STANDARD AND TRIUMPH VEHICLES

No. SPORTS/3/B REINFORCED CAMSHAFT Date JUNE 1954

1 ILLUSTRATION.

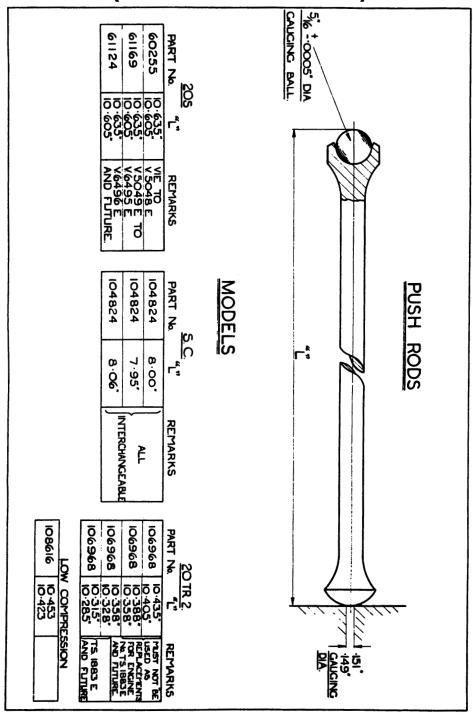
Development work on this engine has shown that at high speeds the deflection of the camshaft, Part No. 301230, under heavy valve spring loading, is a limiting factor in valve clatter speed.

The camshaft has now been stiffened at the front section to reduce this deflection to a minimum, and this provides a greater reserve against over—revving in competition work. This reinforced camshaft, Part No. 301466, was fitted to all engines after Engine No. TS.1636E.

The base radius of all the cams had to be increased with this stiffening of the front section of the shaft, but the lift remains unchanged. The push rod, Part No. 106968, has been decreased in length from 10.37 inches to 10.34 inches, this dimension being measured as shown in the illustration. Although the shorter push rod is being used in production with the reinforced camshaft to provide the widest range of adjustment it is not necessary to change push rods when replacing the earlier camshaft by the modified one.
